Re: Second Submission Review – Green Valley Ranch East Site Plan No. 5 - Site Plan Amendment No. 2 Minor Site Plan Amendment and Plat

Application Number: **DA-1662-23**

On behalf of Oakwood Homes and Terracina Design, we have reviewed the comments dated March 22, 2022. The following is a response to comments.

Second Submission Review

SHEET 2 OF 2

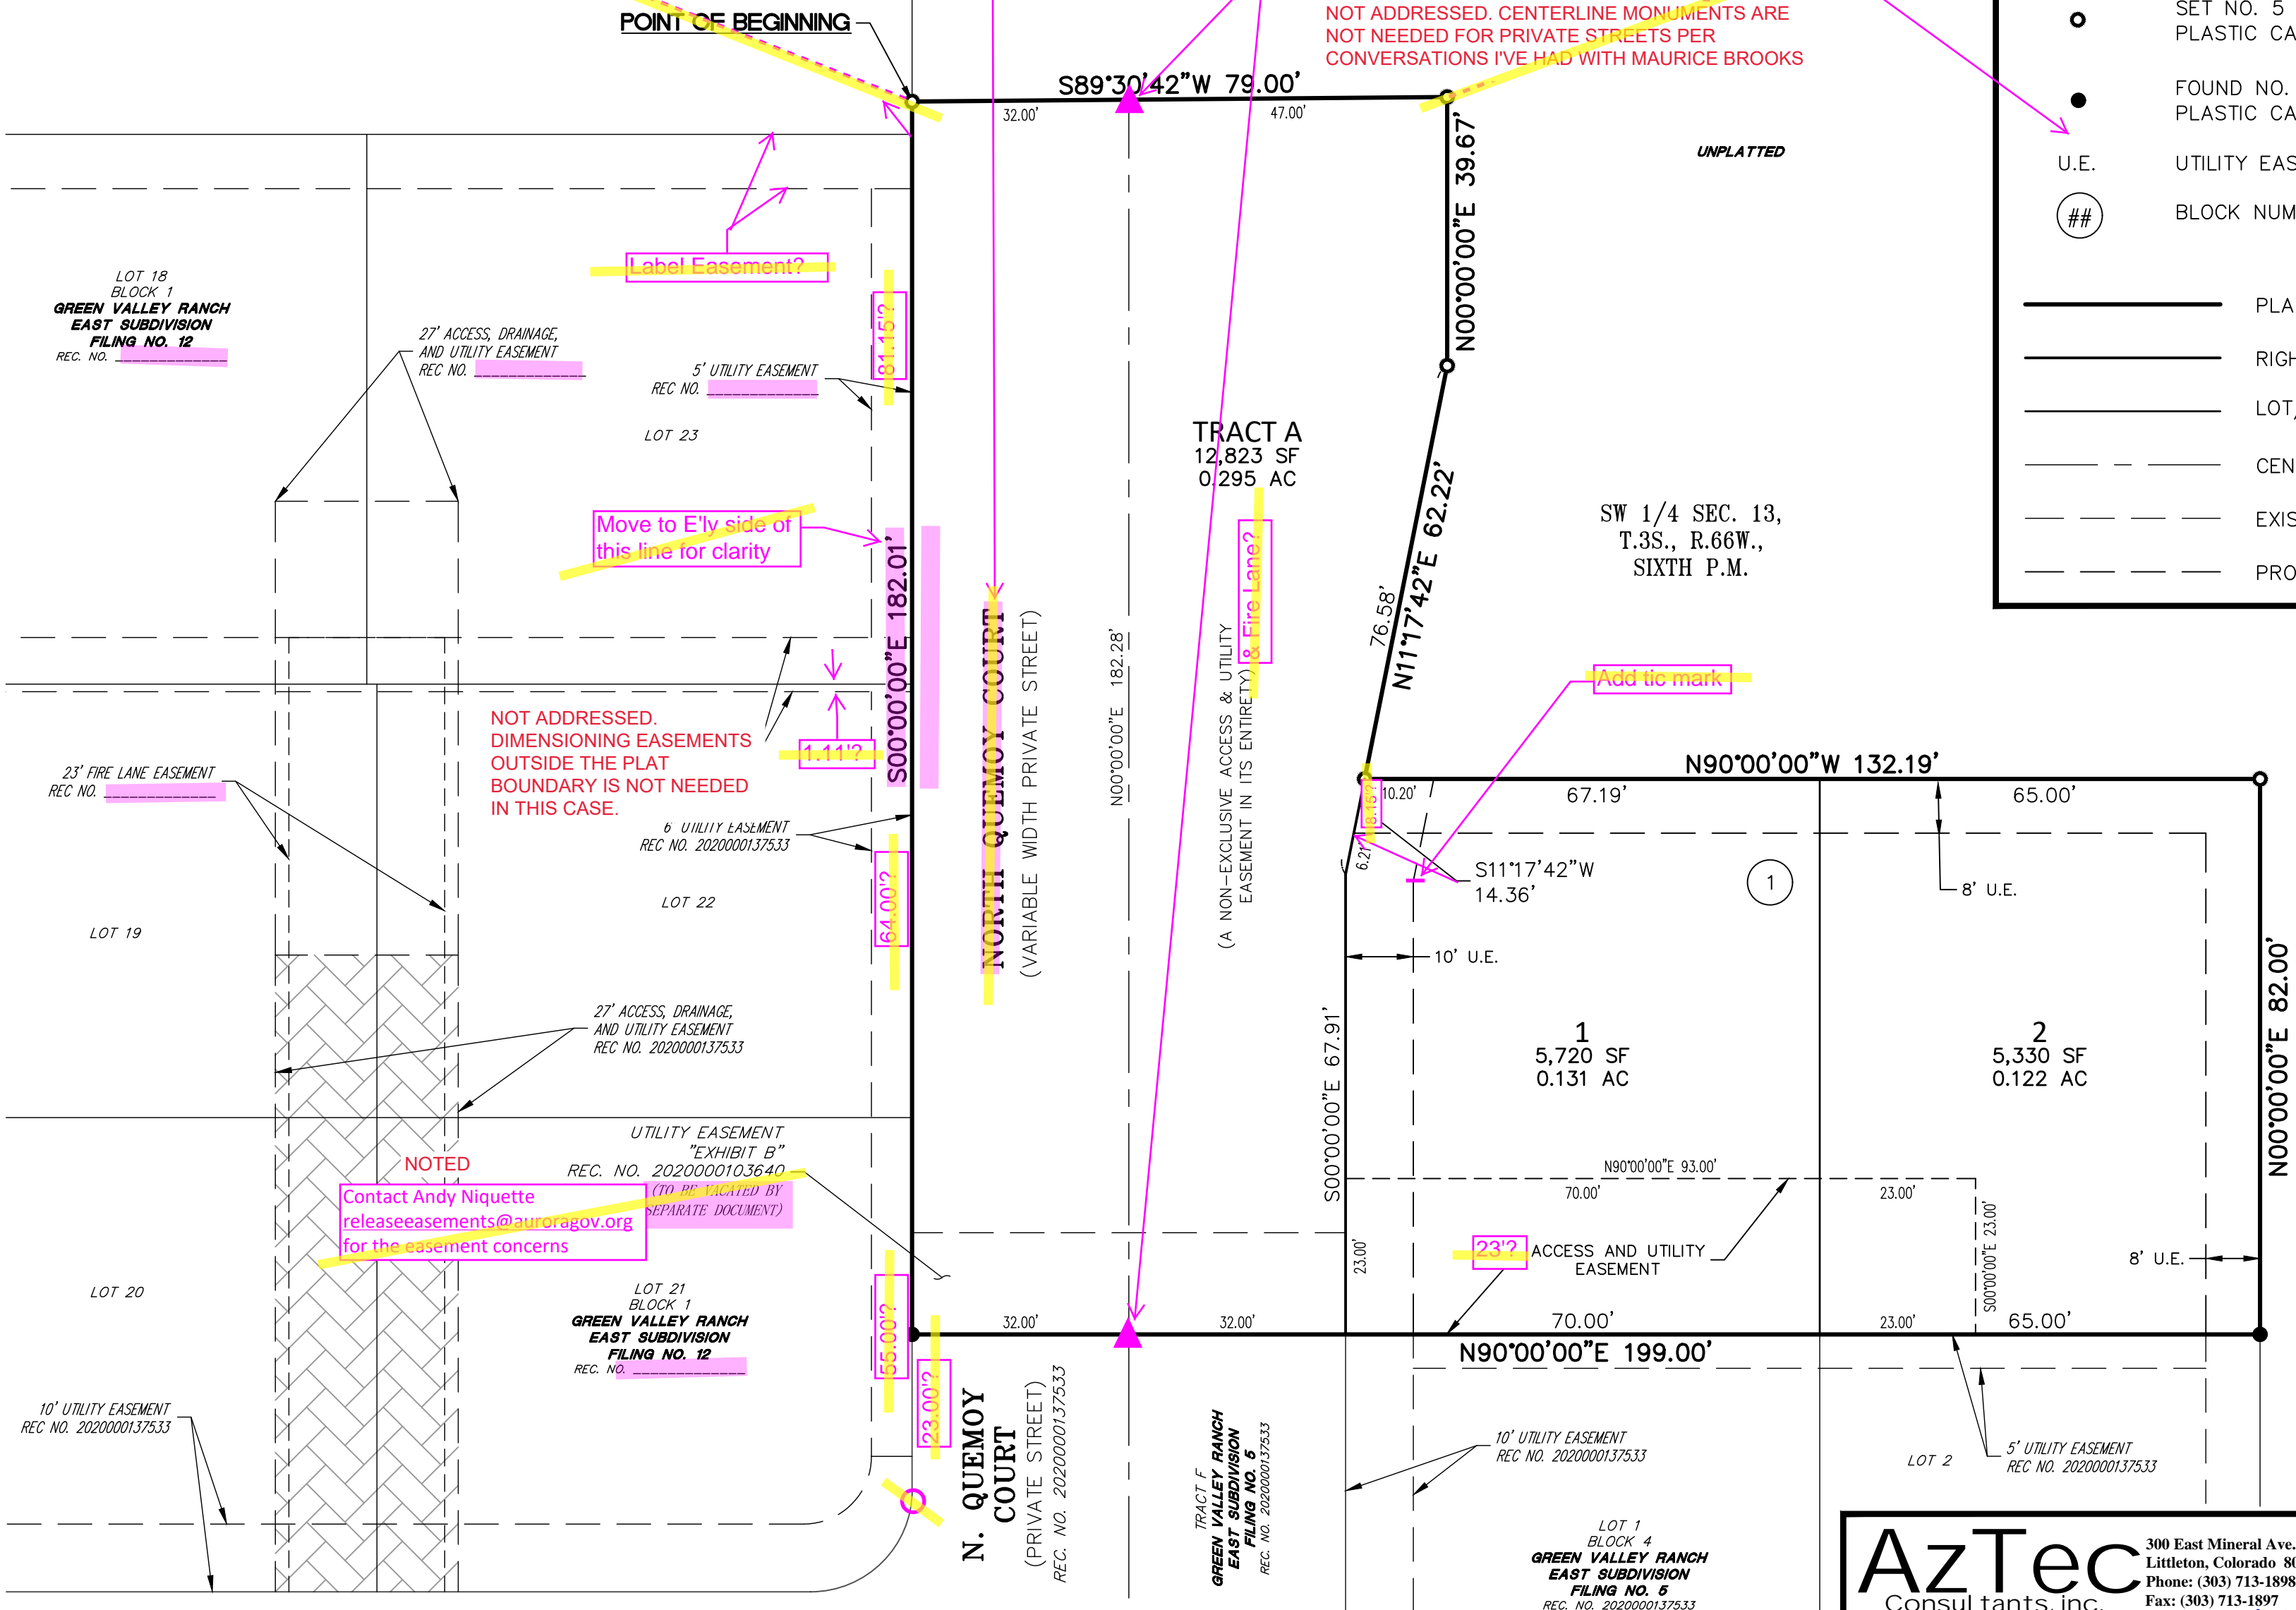
Show all public street rights-of-way (ROW), alleys, and their widths and street
names. If the ROW varies, you can either show the dimensions in various areas
or "ROW varies". If the ROW or alley exists, show the recording information
that created it. Do not dedicate public rights-of-way as tracts. **Do not show
street names, if streets will be private (owned by someone other than the
City).** If roads are private, they need to be shown as tracts and dedicated to the
City as "Access, Utility, and Fire Lane easements" (typically).

13(6) Show a tie-out distance and bearing to the exterior boundary of
the subdivision from at least two control corners (i.e., section corners,
aliquot corners, existing plat boundary corner, existing lot corner, or a
monument box in centerline of abutting street right-of-way, etc.).

NOT ADDRESSED. CITY OF AURORA HAS IN THE PAST ASKED THAT WE SHOW
STREET NAMES FOR PRIVATE STREETS REGARDLESS OF ITEM 16 NOTED
BELOW. PLEASE SEE OTHER FILINGS IN GVRE FOR REFERENCE.

NOT ADDRESSED. SEE
SOUTHERLY BOUNDARY.
